CITY OF DOVER

PLANNING TECHNICAL REVIEW COMMITTEE –AGENDA

1. Site Plan Amendment for Jones & Beach Engineering (Owners: The Dover Condominium & Essential Properties, LLC), Assessor's Map 38 & 37, Lots 6-A & 24, zoned C, located at 851-888 & 829-833 Central Avenue. (Proposal is to convert former department store to Traene fitness facility consisting of 10 pickleball courts and fitness areas with a 24' wide driveway connection between the two parcels.) (WAIV-2025-0012) [This item was previously heard by the Planning Technical Review Committee on November 6, 2025.]

RE: Response Letter
829-833 & 851-881 Central Avenue, Dover, NH
Tax Map 37, Lot 24
Tax Map 38, Lot 6A
JBE Project No. 20523

INSET - HANNAFORD/SHAW'S ENTRANCE CONNECTION
SCALE: 1" = 20'

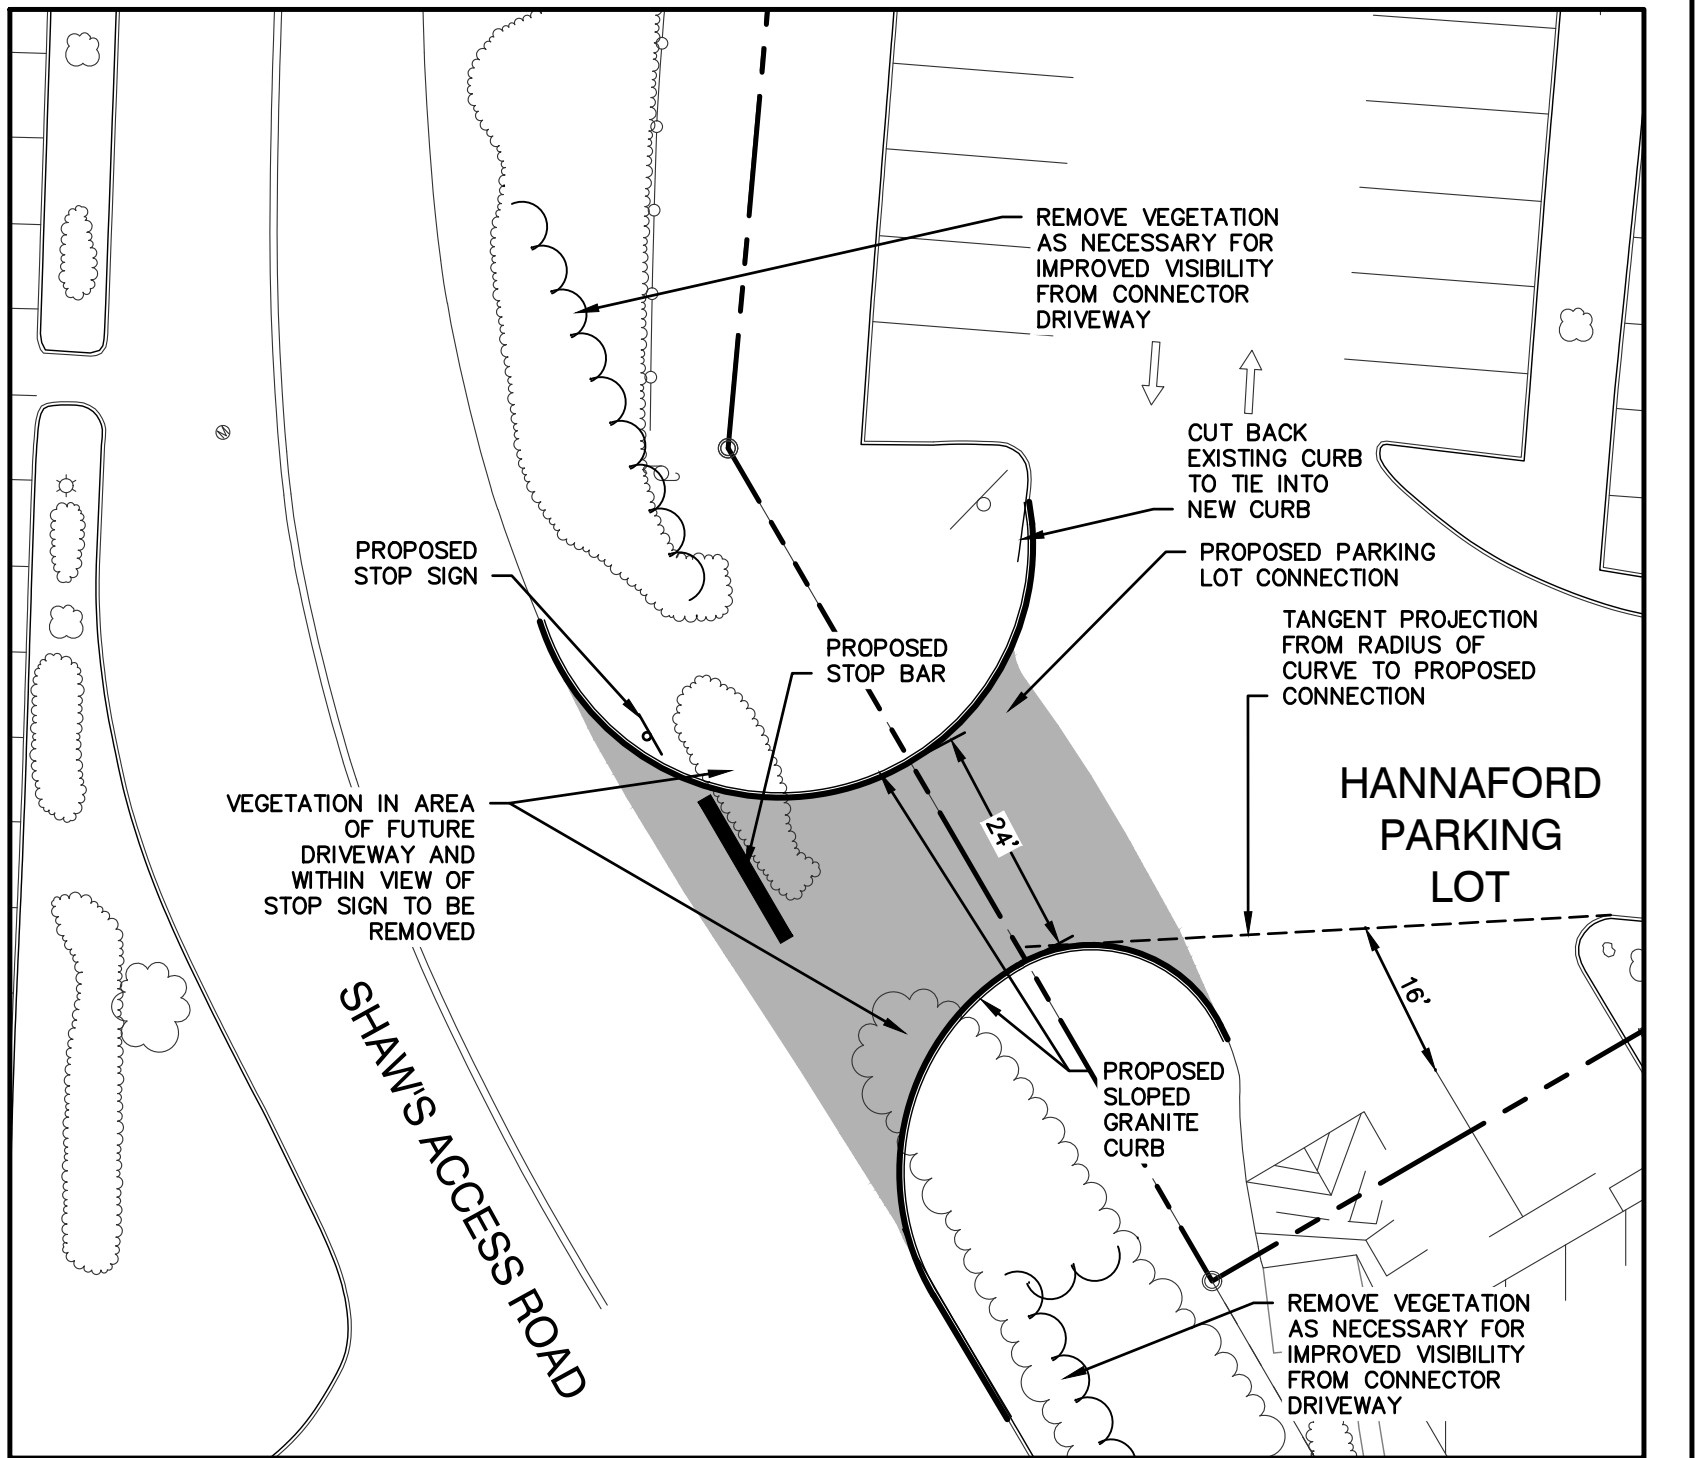
- Connector to Shaw's plaza appears to be installed on a radius. Clarify visibility. A stop sign was not noted at the intersection- please consider and provide sign location with posting and mounting detail within plan set.

Response: A stop sign and stop bar have been added to the plans (See Sheet C2) and we are happy to add any additional signage the City feels is necessary. See also stop sign and stop bar details on Sheet D2.

Plan Name:	SITE PLAN
Project:	DOVER TRAENE FITNESS 831 CENTRAL AVE, DOVER, NH
Owner of Record:	CALICO PROPERTIES LLC 304 MAPLEWOOD AVE, PORTSMOUTH, NH 03801

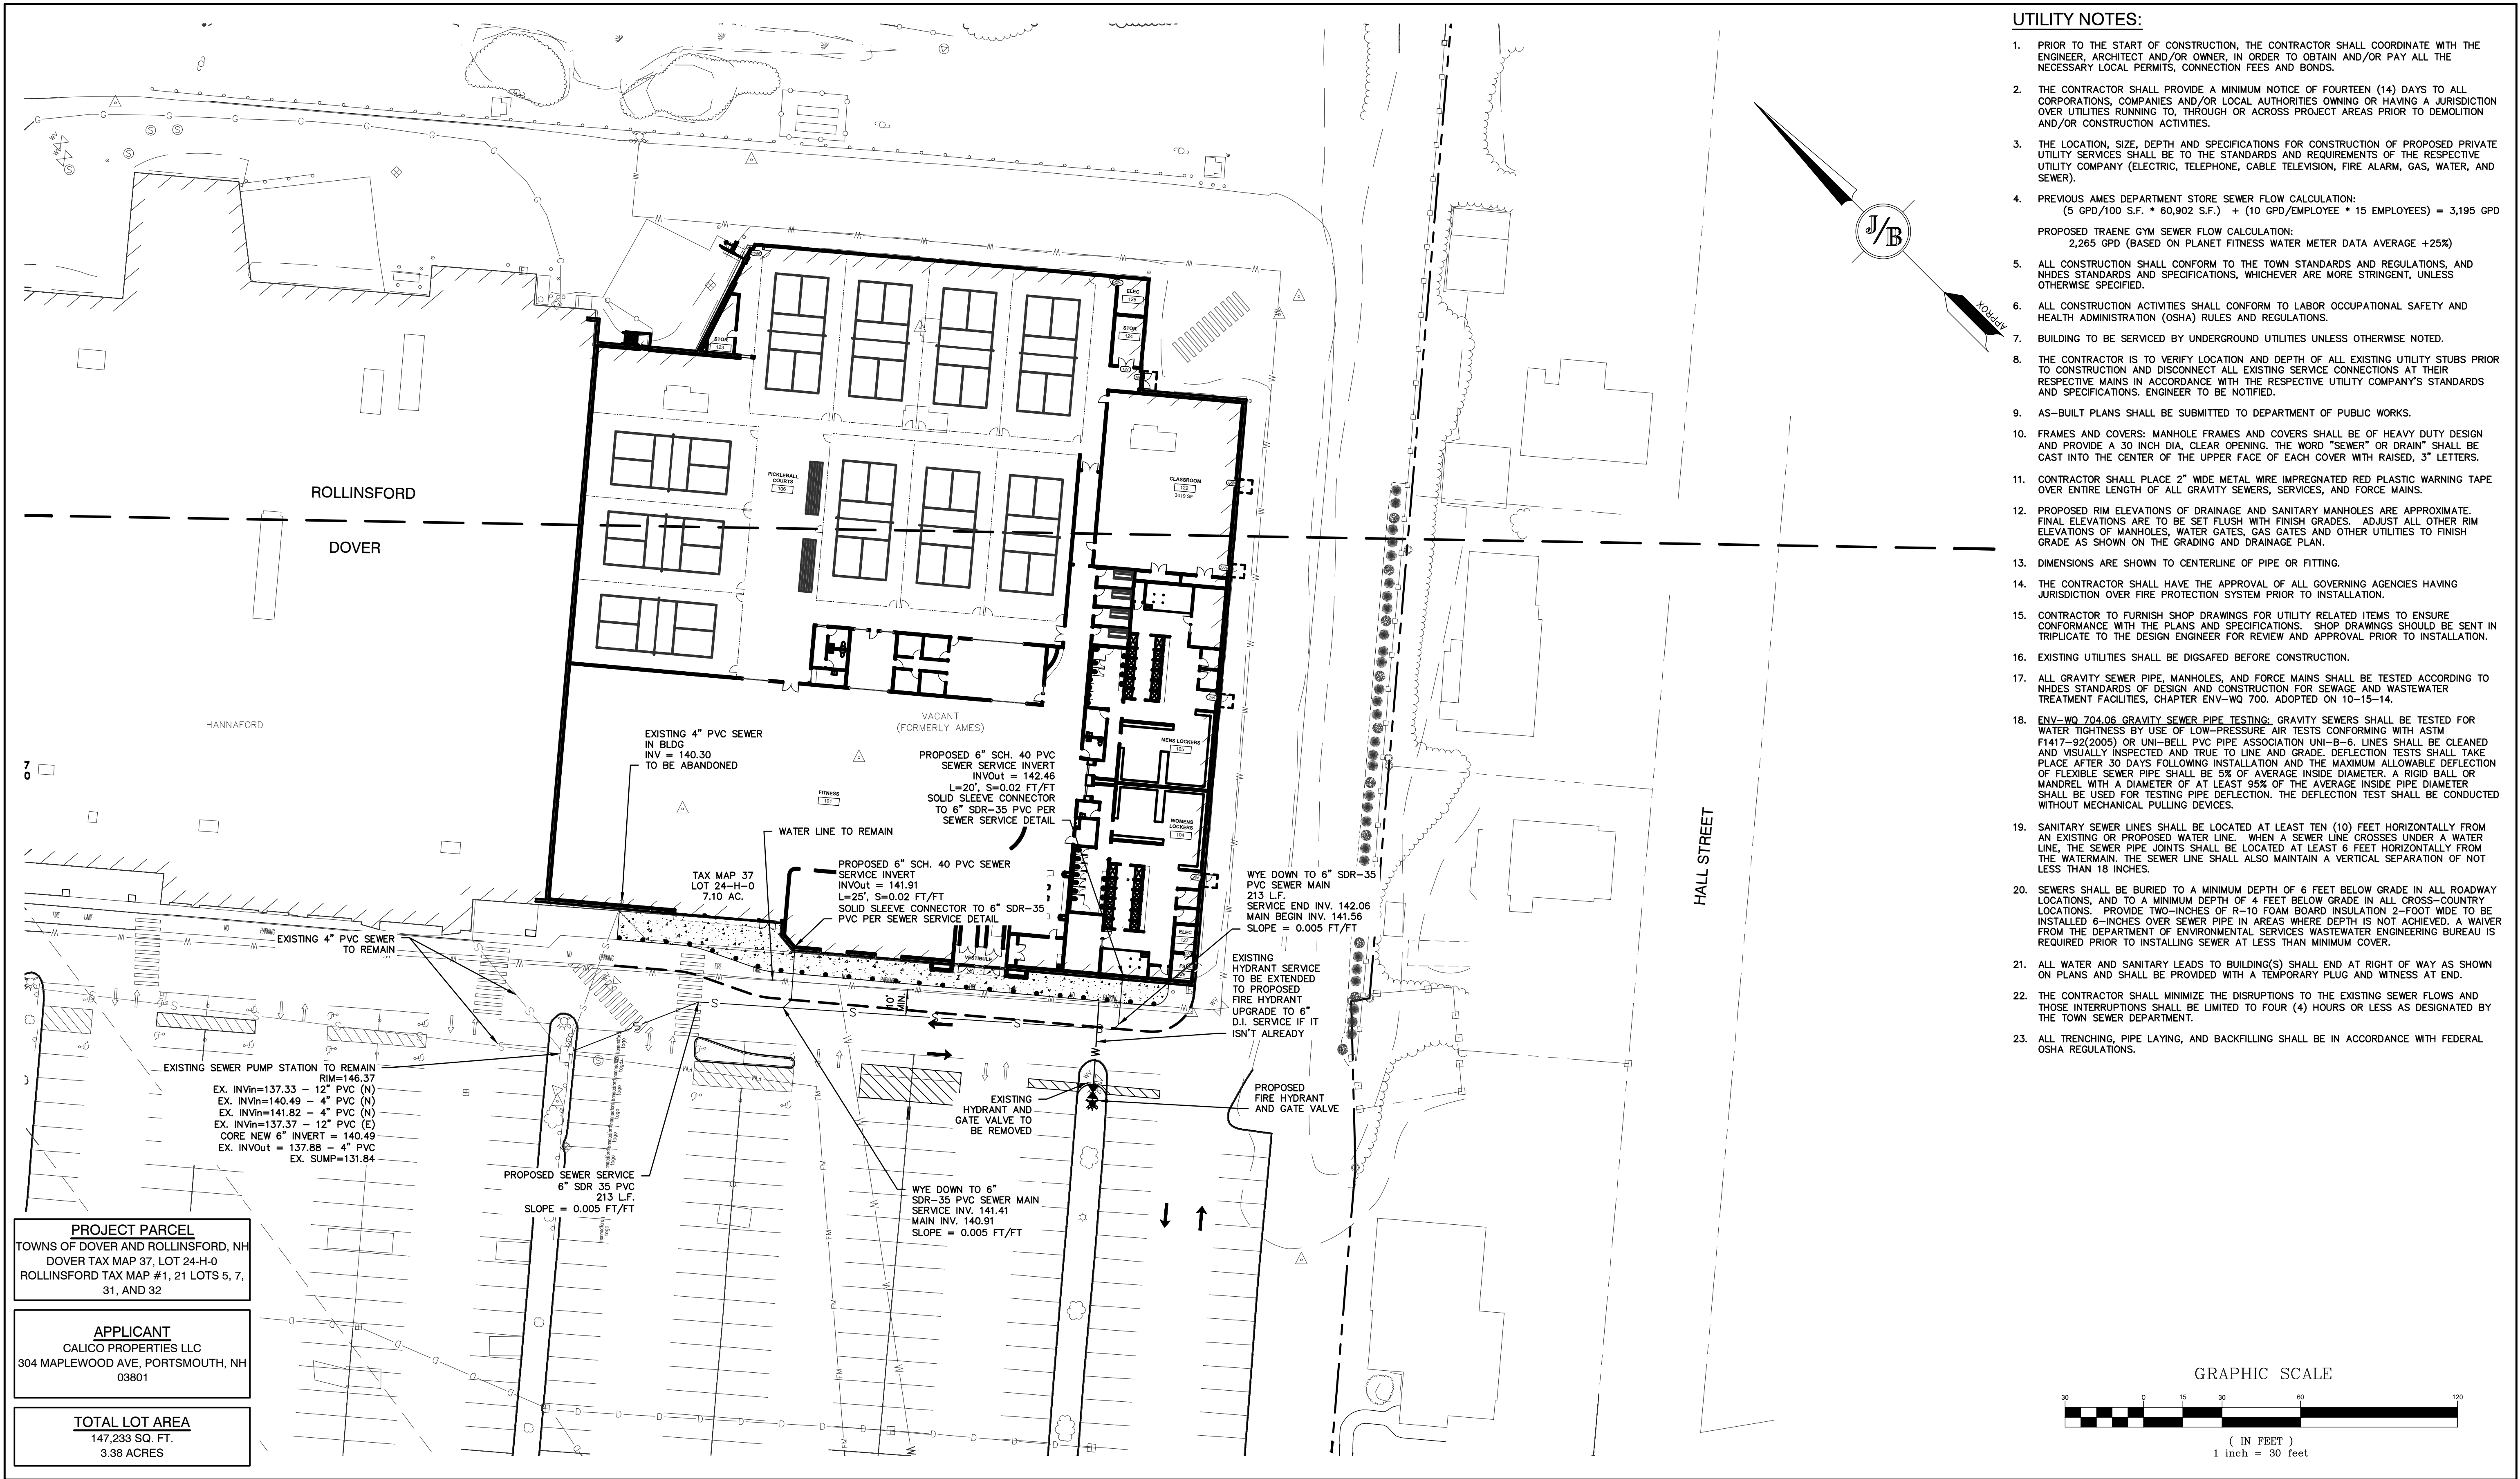
- *Stop sign, traffic flow for that created intersection?*
Response: A stop sign has been added to the plans as shown on the inset on Sheet C2, and a trip generation memo is included in this resubmission.

- *Connector to Shaw's plaza appears to be installed on a radius. Clarify visibility. A stop sign was not noted at the intersection- please consider and provide sign location with posting and mounting detail within plan set.*

- *Reminder: water and sewer investment fees as applicable*
Response: These will be paid as required.
- *Provide letters to serve from utilities prior to Planning Board.*
Response: The building is already serviced by all necessary utilities.
- *Has any coordination been done with the Town of Rollinsford?*
Response: We have reached out to the Town of Rollinsford and will obtain all necessary permits from them if required. No work is proposed in Rollinsford.
- *Landscaping along the eastern boundary was recently removed and replaced. Please include updated landscaping on plan set.*
Response: The new landscaping has been located and added to the plan set as shown on Sheet C1.
- *What are the proposed hours of operation?*
Response: Hours of operation will be 24 hours per day, 7 days per week. See Note #16 on Sheet C2.

Response: This has been added to Note 3 on Sheet C2.

Response: A double-faced van-accessible handicap parking sign has been added for the proposed handicap parking spaces as shown on Sheet C2. A detail for this sign has been added to Sheet D2.

Response: Sight distance measurements as well as a stop sign have been added to the plans. See responses to police comments above.

Plan Name:	UTILITY PLAN
Project:	DOVER TRAENE FITNESS 831 CENTRAL AVE, DOVER, NH
Owner of Record:	CALICO PROPERTIES LLC 304 MAPLEWOOD AVE, PORTSMOUTH, NH 03801

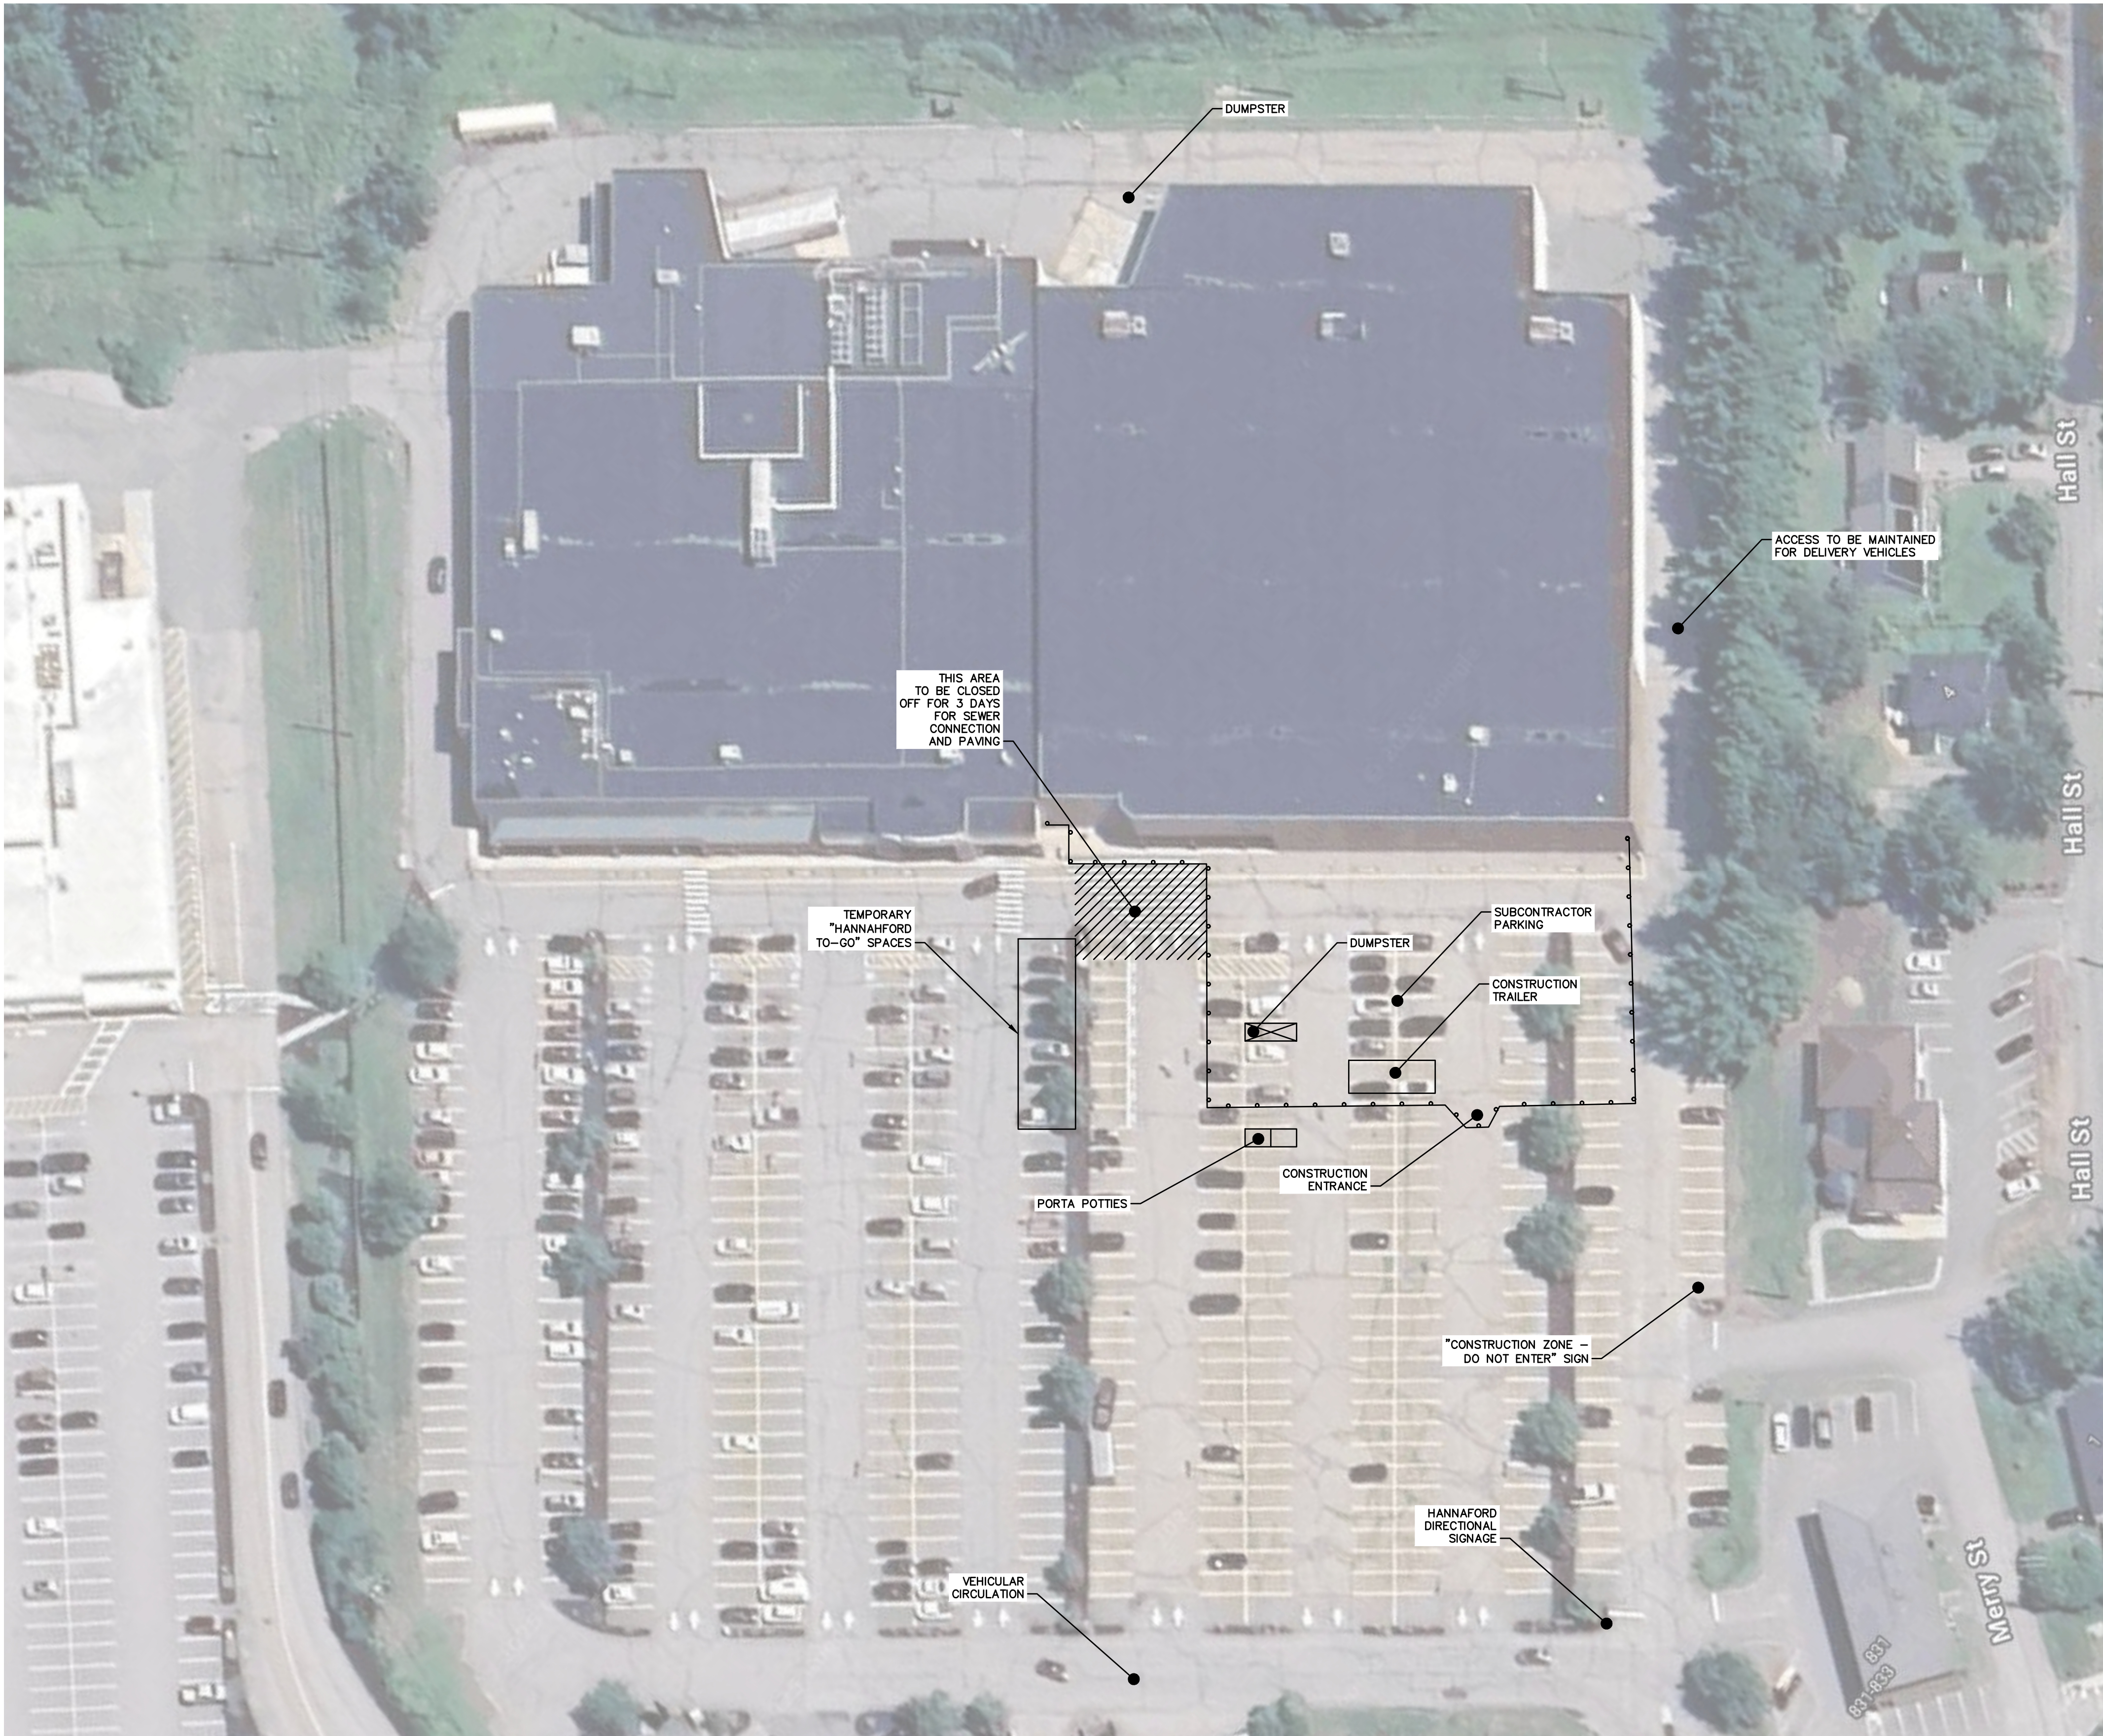
- *Clarify scope of work associated with the sewer pumping station.*

Response: The flow calculations are outlined in Note 4 on Sheet C4 of the plan set. It is anticipated that the flow will be reduced from what the pump station was originally designed for which was an Ame's Department Store.
- Water/sewer investment fees will apply for additional flow*

Response: The connection from the existing water main to the proposed fire hydrant is shown on Sheet C4.
- Specify proposed 6" sewer material.*

Response: The sewer pump station is to remain. A new invert is being cored into the pump station for an additional service from the building as noted on Sheet C4.
